The TP Central Odisha Distribution Limited

Specification Name: Technical Specification for Trolley Mounted Distribution Transformer

Tender Enquiry No.: TPCODL/P&S/1000008961/26-2

DATE:- 20-06-2026

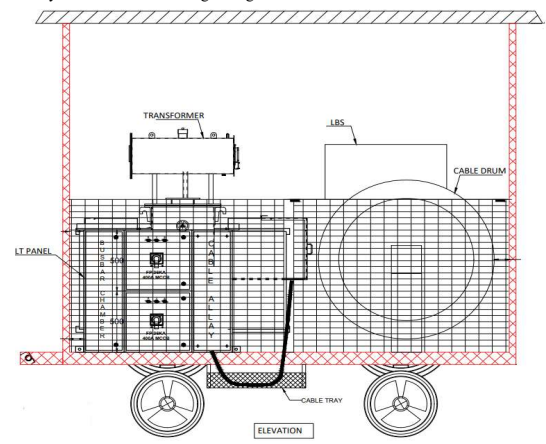
6	ENG-GEN-4001	Page 10 of 20	5.1 TROLLEY & EQUIPMENT ARRANGEMENT	k) Canopy shall be provide above the equipment with vertical round pipe support arrangement on the trolley, so that rain water shall not be directly fall on the equipments. Height of the canopy should be 750mm above the highest point of the equipment installed on the trolley.	Please provide the details for canopy ,drawings or photo graphs for the same.	Trolley Canopy shall be made of 3 mm thick GI sheet with powder coating of minimum 80 microns. The indicative section drawing is attached for reference. Bidders shall submit detailed layout and section drawings along with the technical bids.
